THE RIDGE AT LORSON RANCH FILING NO. 1

FINAL PLAT
THE RIDGE AT LORSON RANCH
FILING NO. 1
JOB NO. 70-097
DATE PREPARED: 01/11/2022
DATE REVISED: 03/31/2022

PCD FILE NUMBER SF-22-004

Final Plat Drawings_v2.pdf Markup Summary 5-5-2022

SHEET 4 OF 10

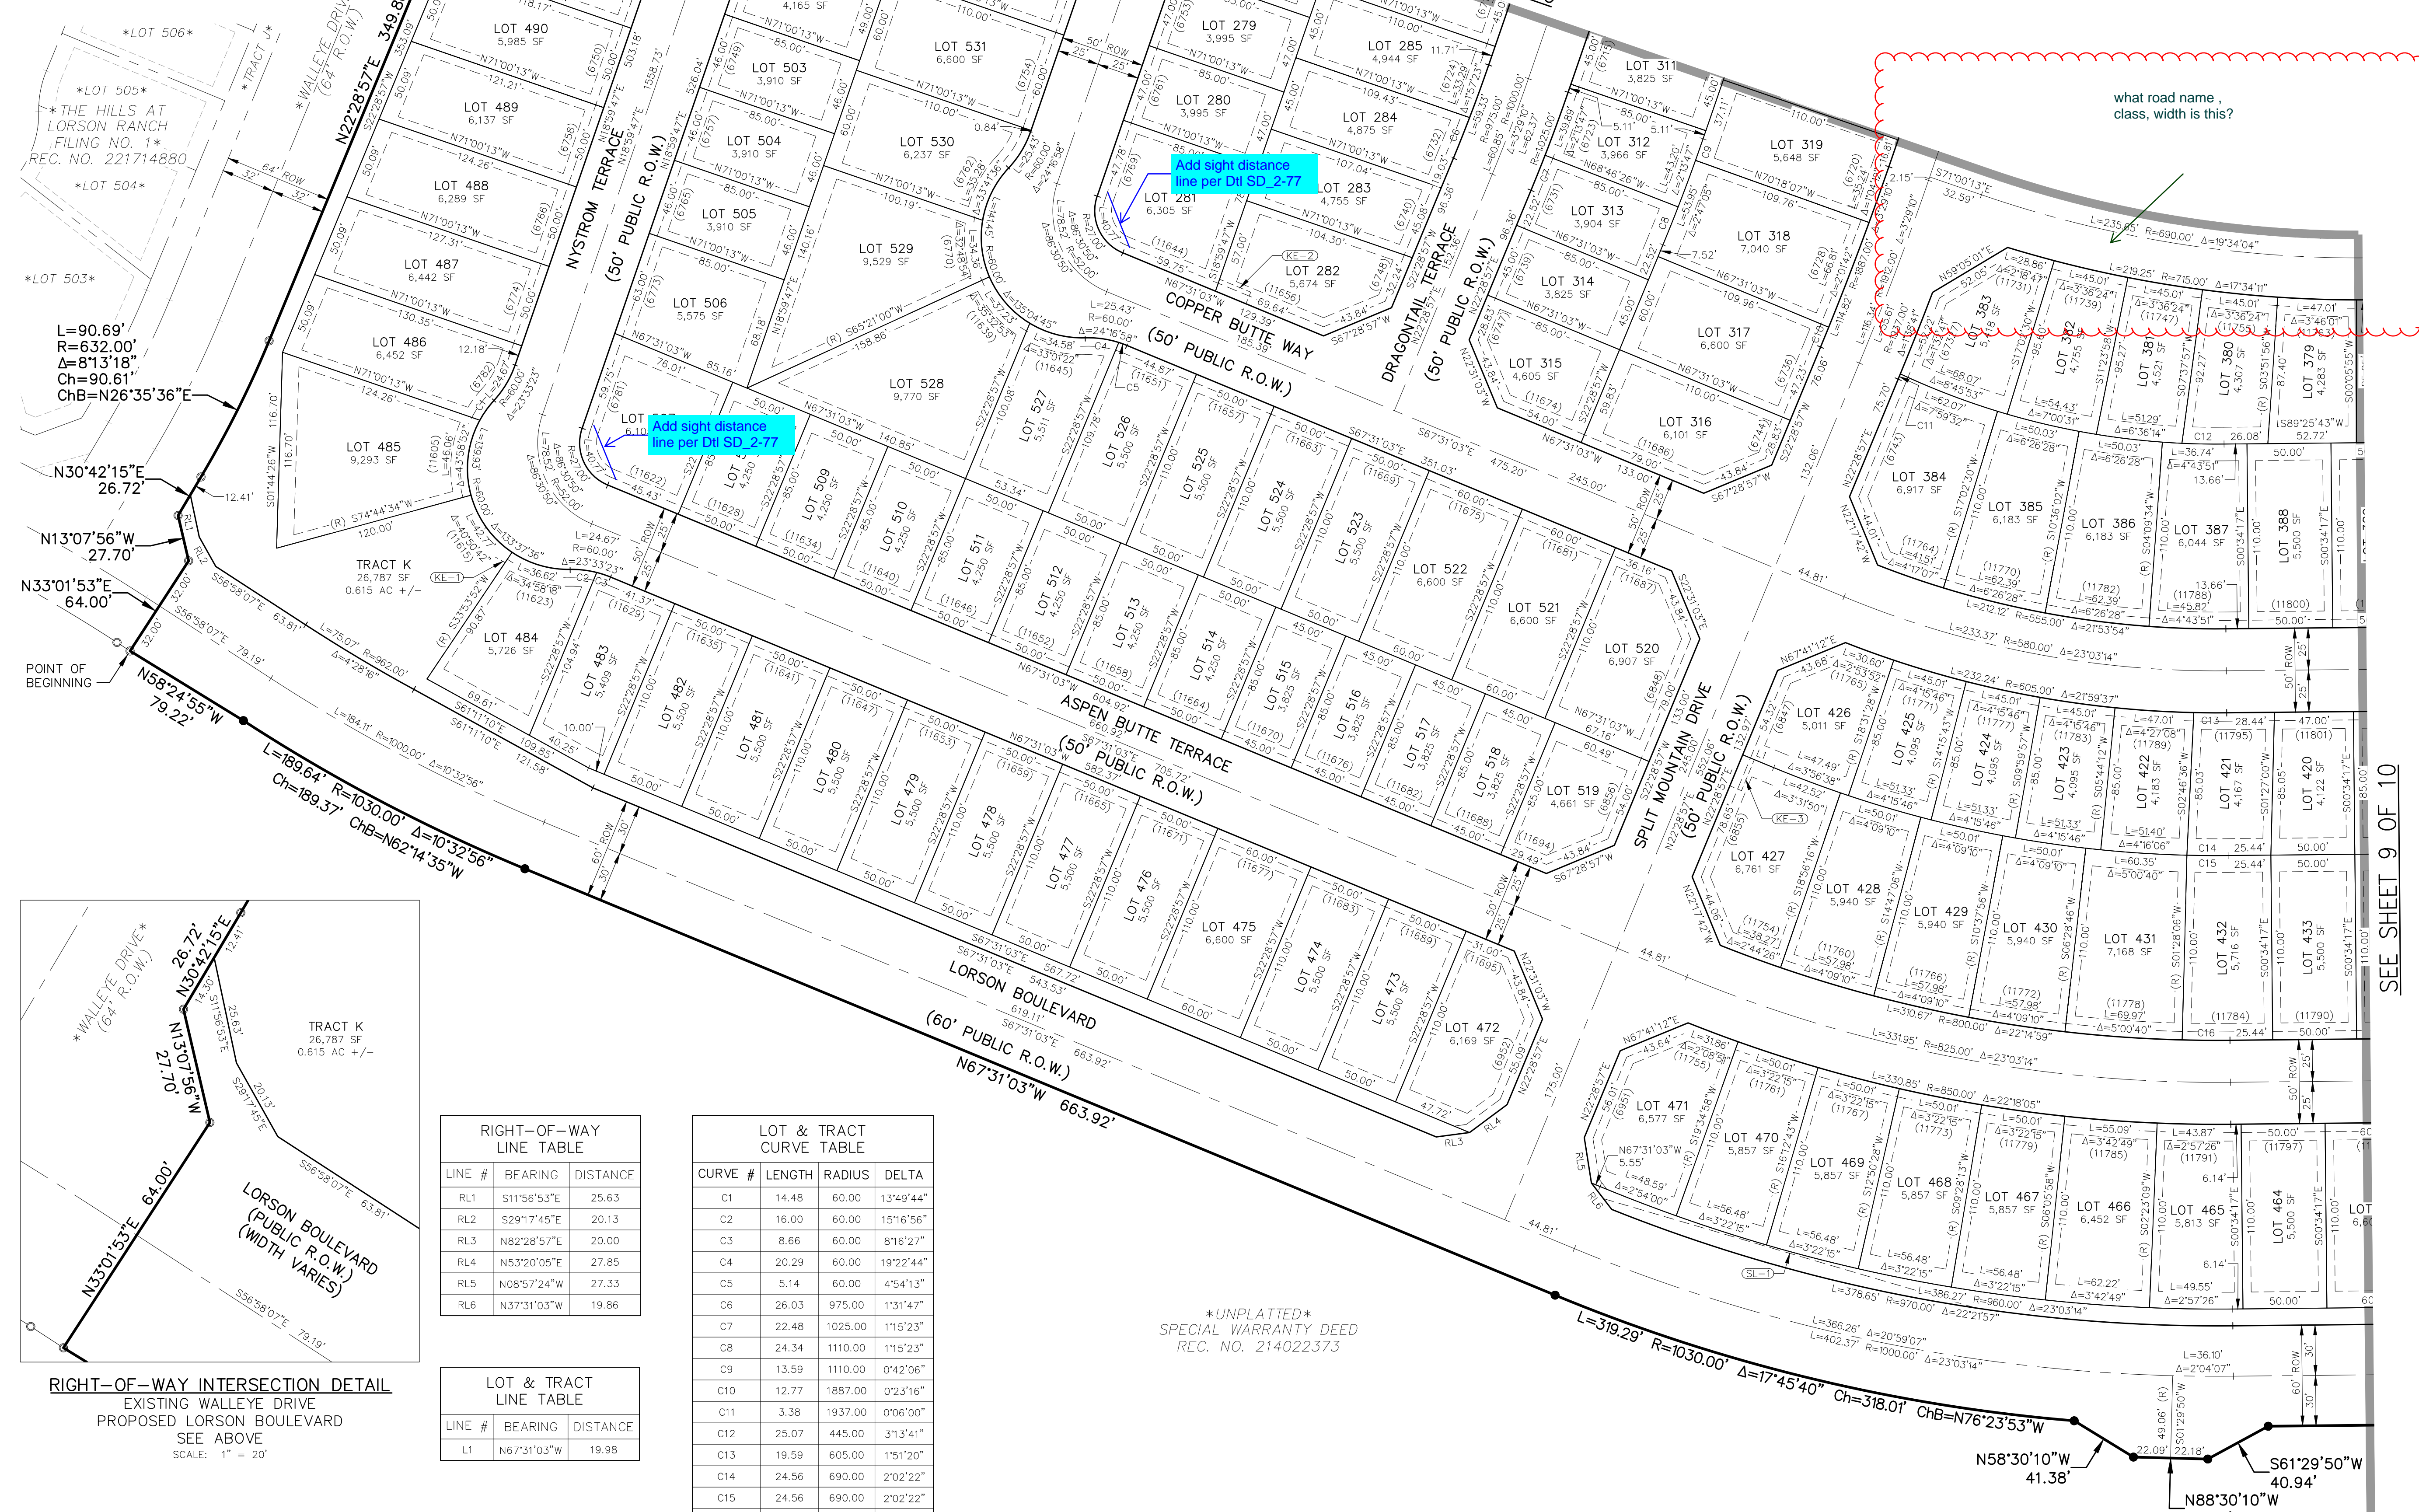
what road name , class, width is this?

Add sight distance line per Dtl SD_2-77

Add sight distance line per Dtl SD_2-77

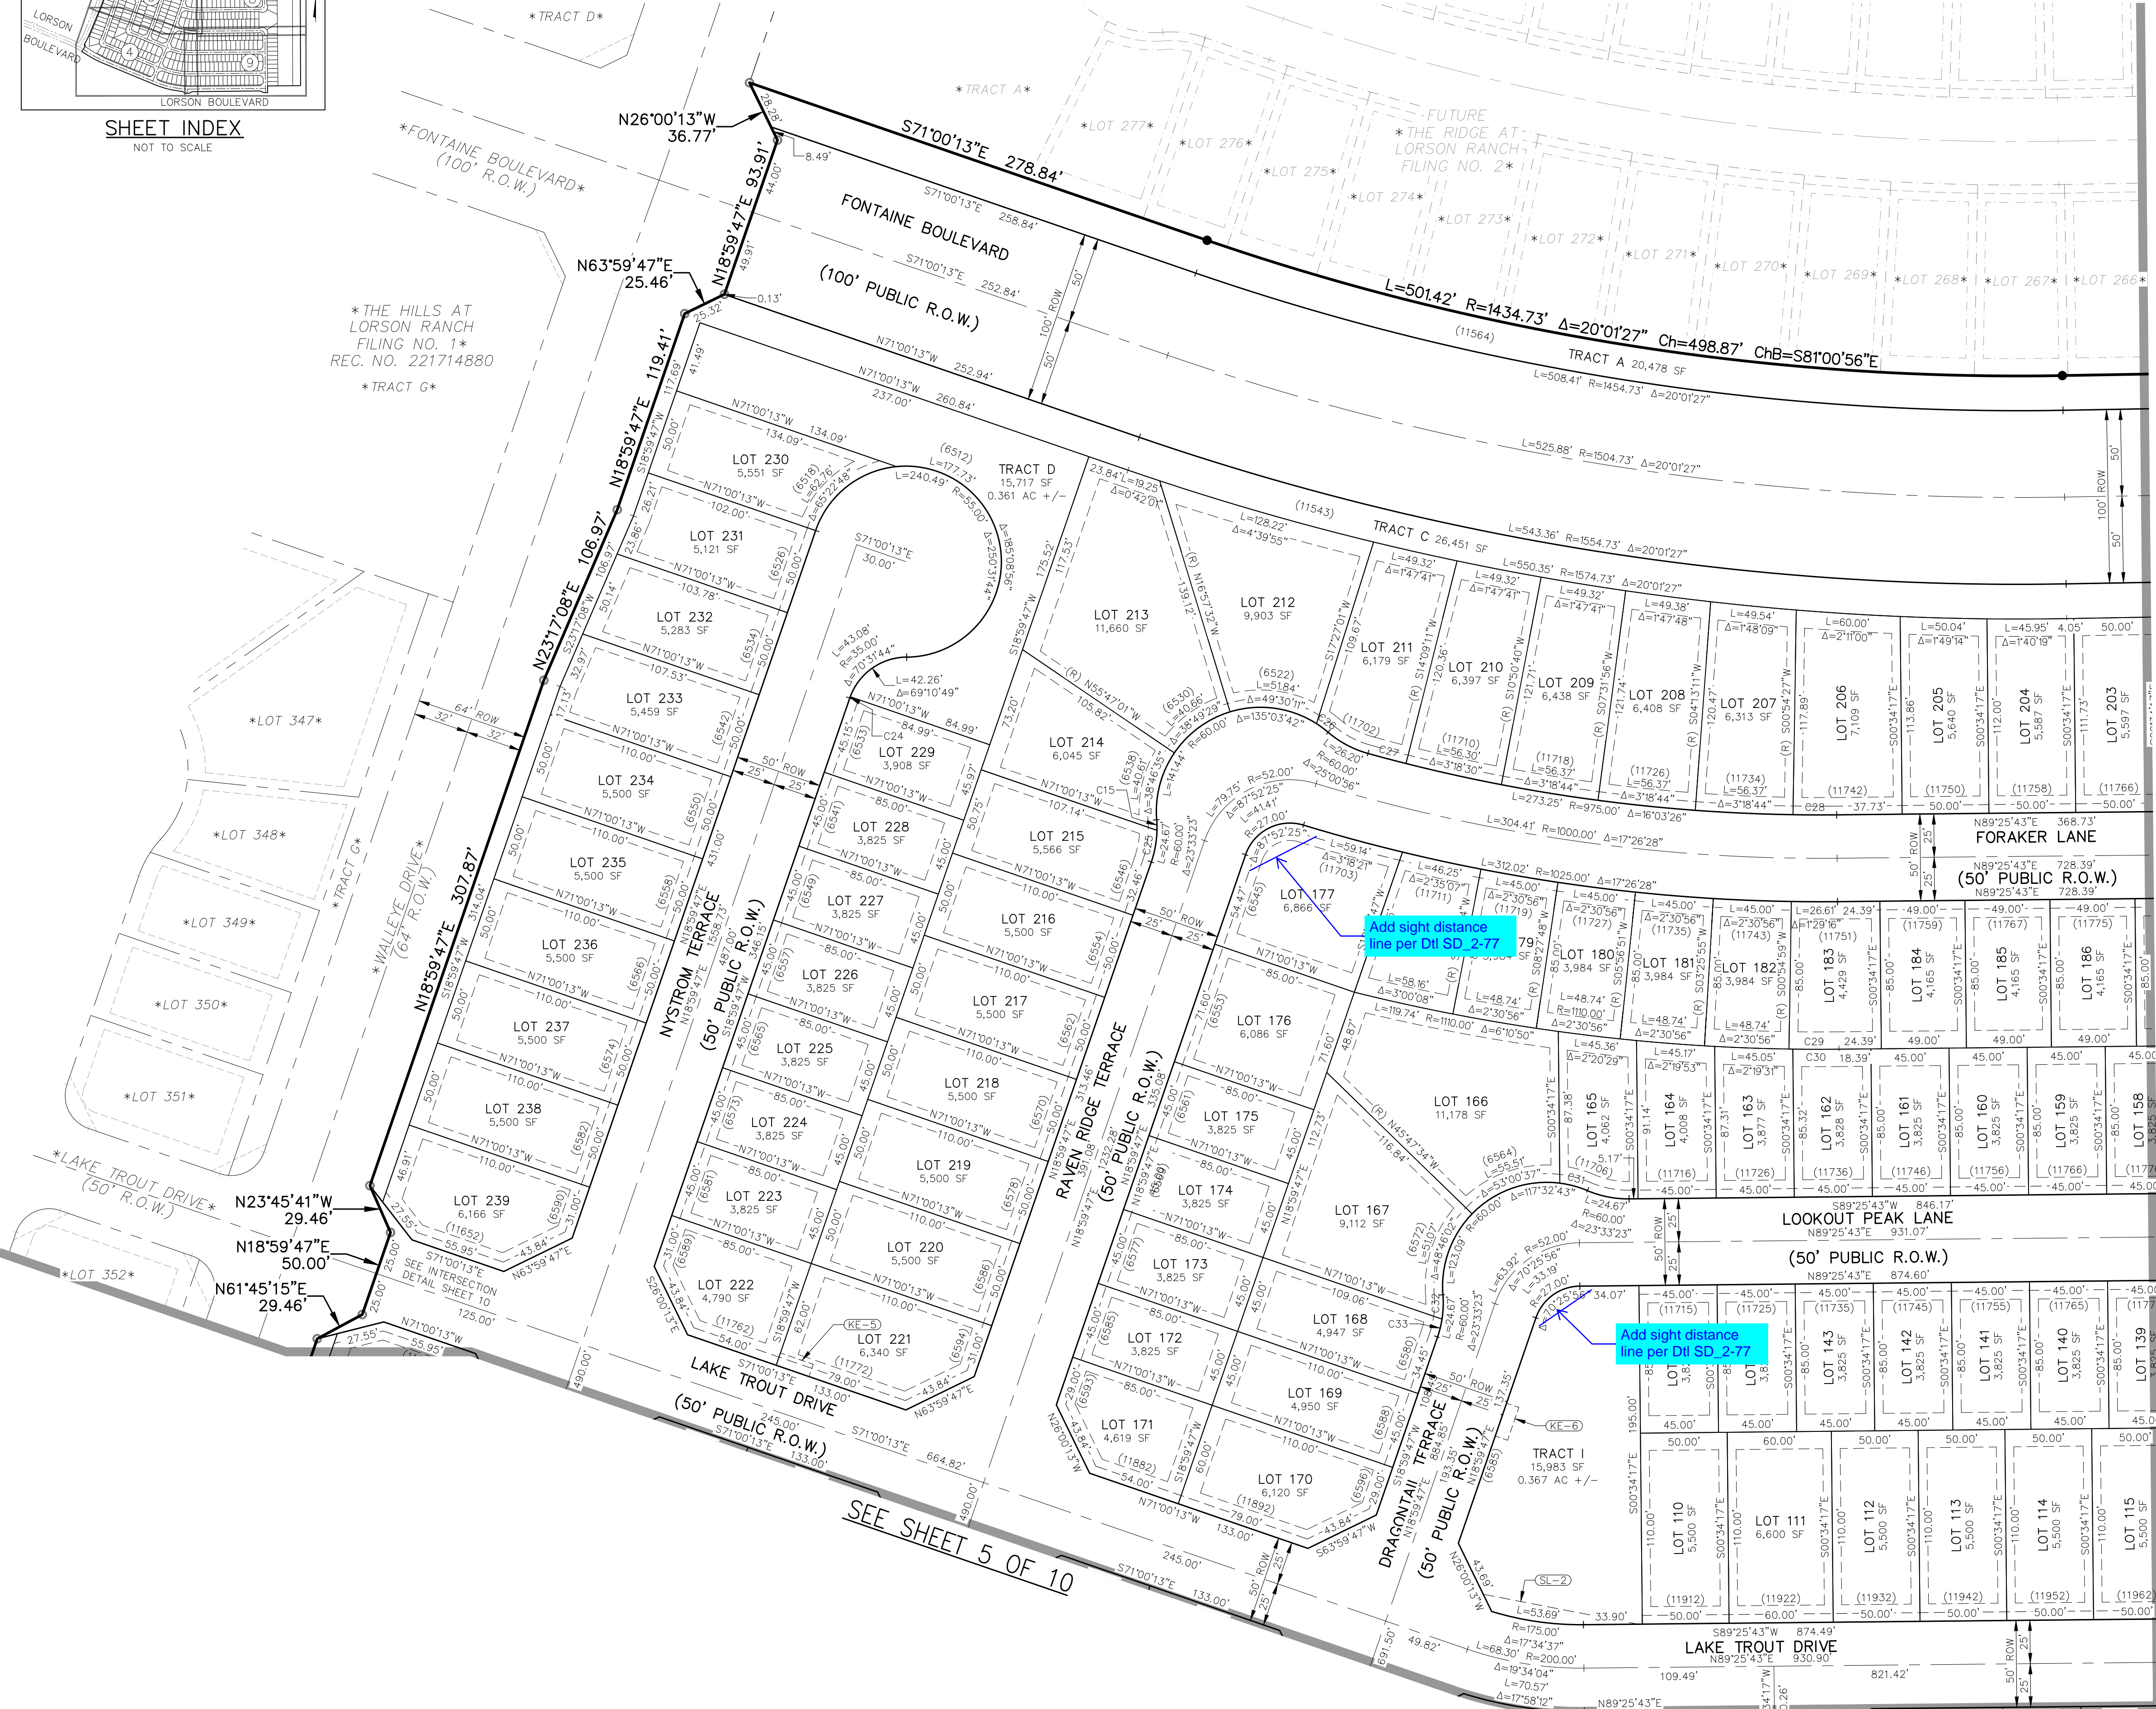
Add sight distance line per Dil SD 2-77

Add sight distance line per Dil SD 2-77

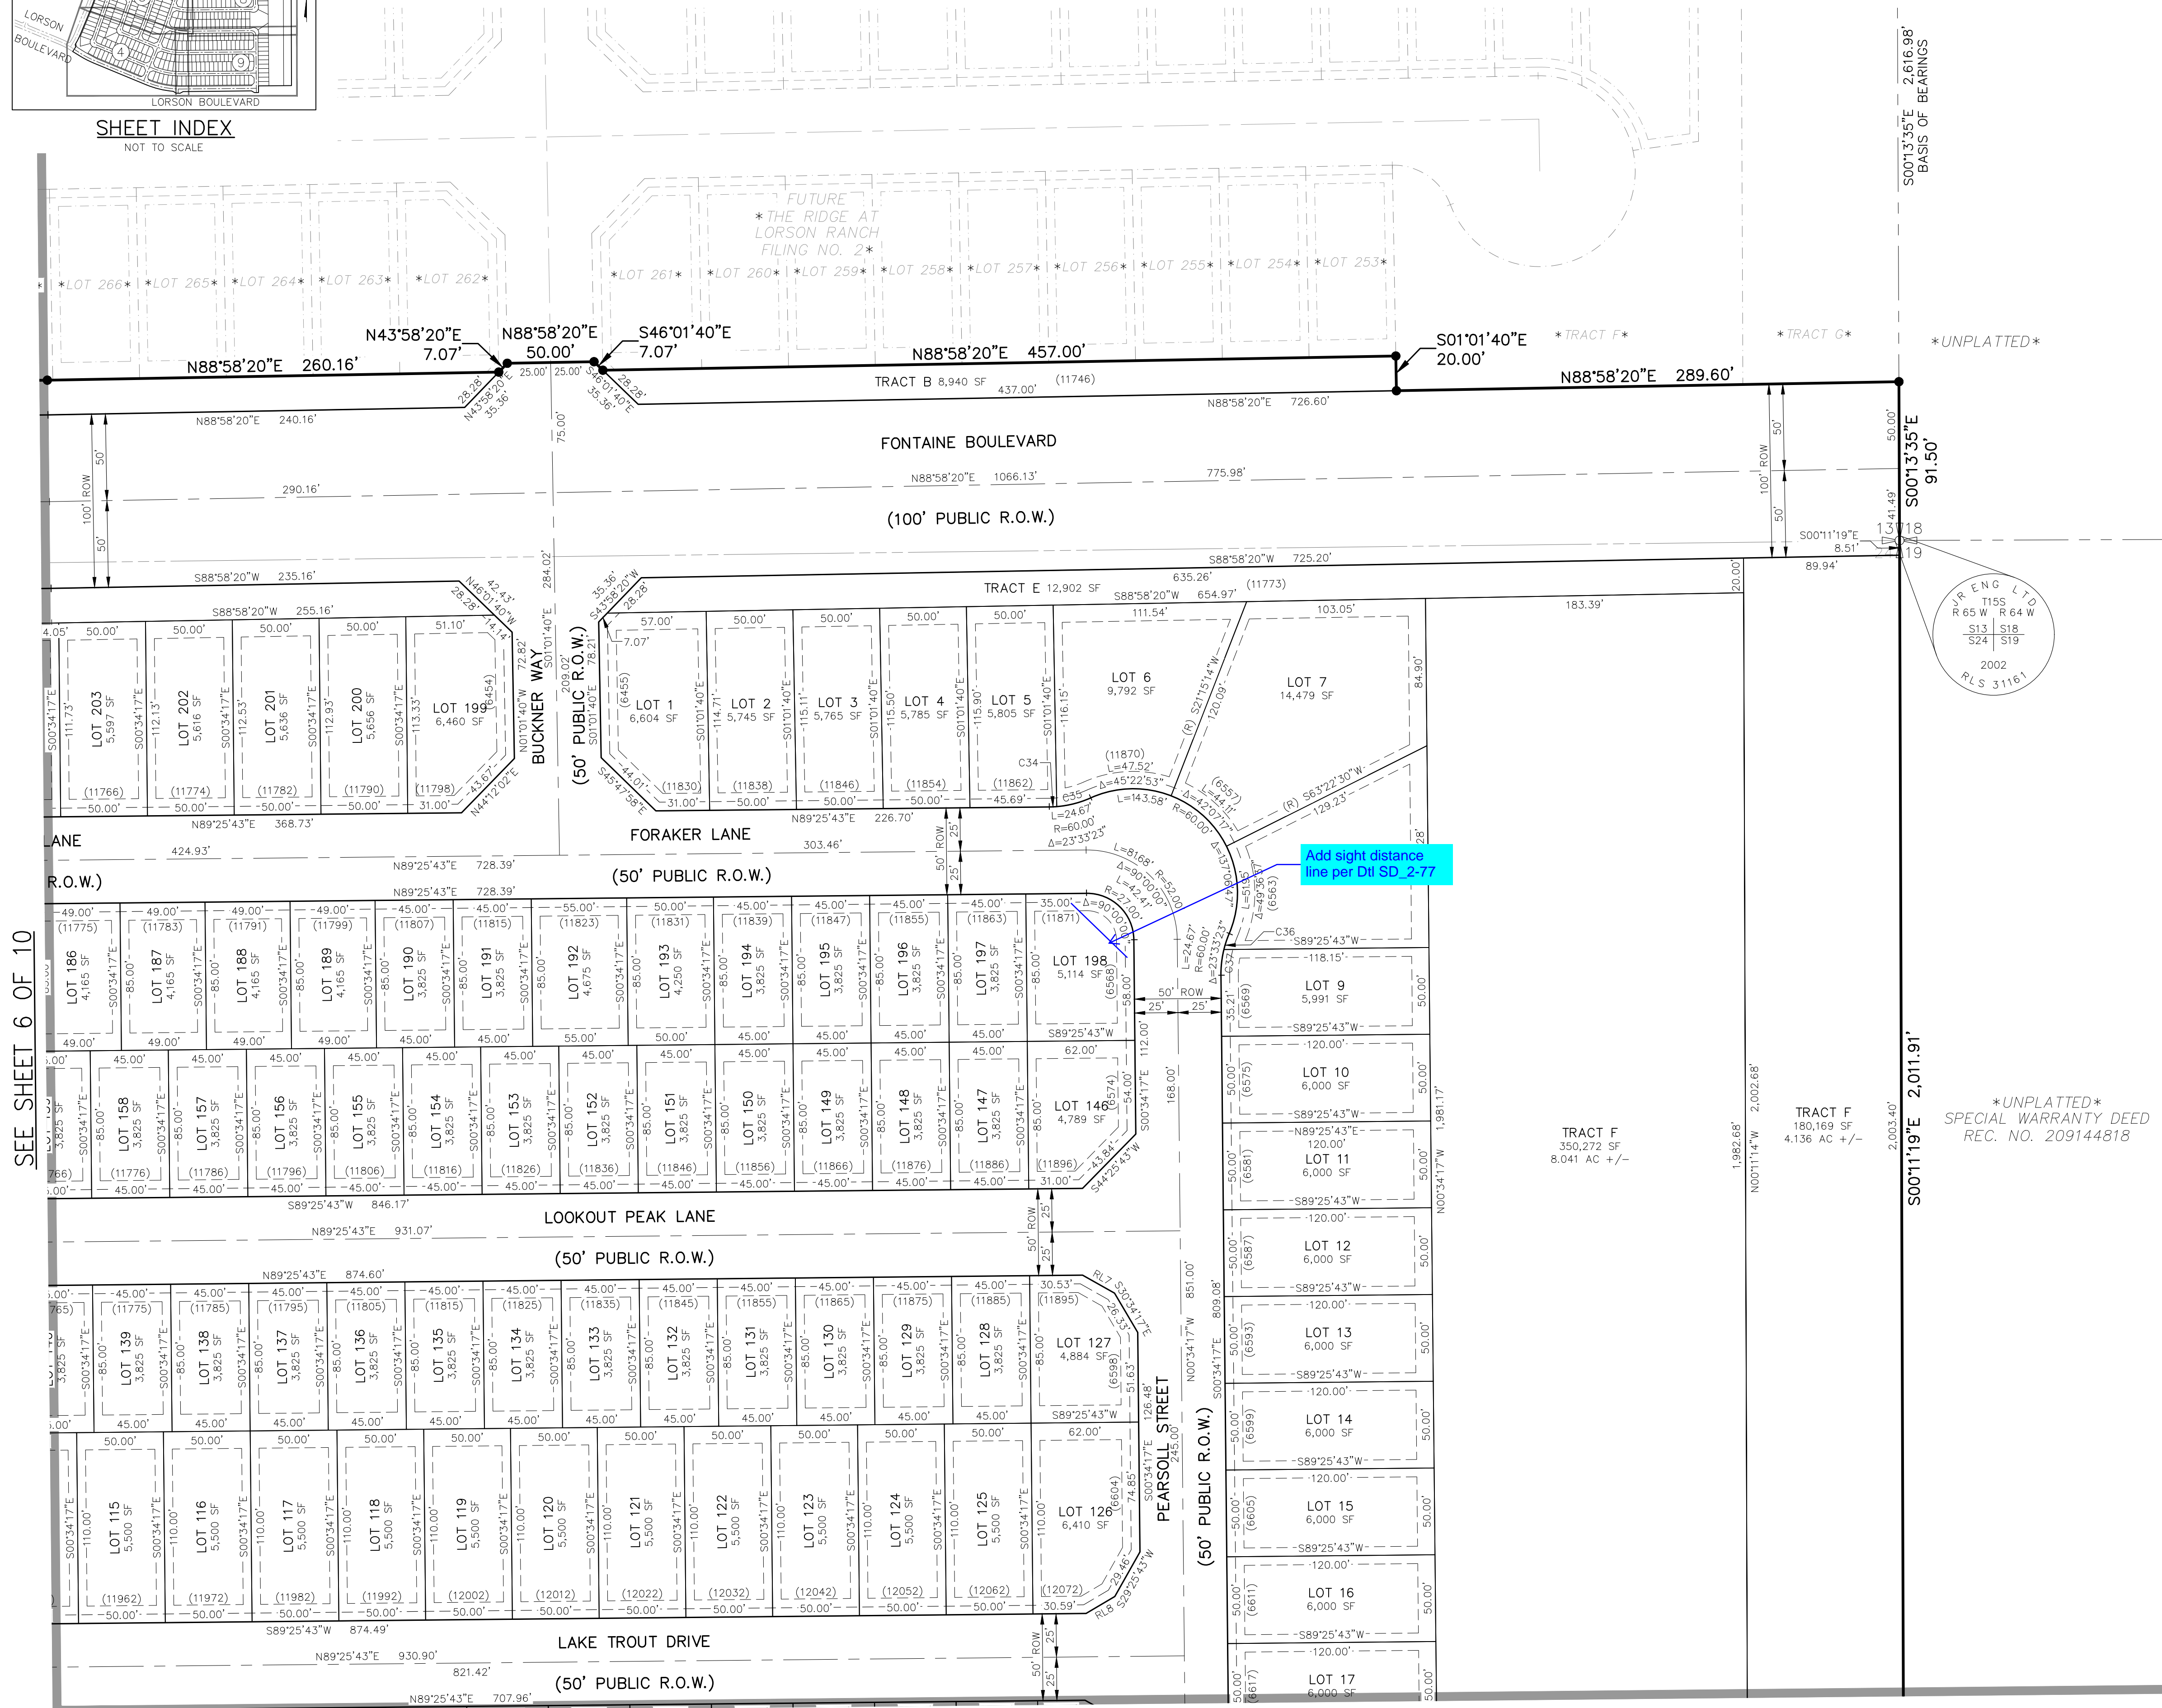
Add sight distance line per D1 SD 2-77
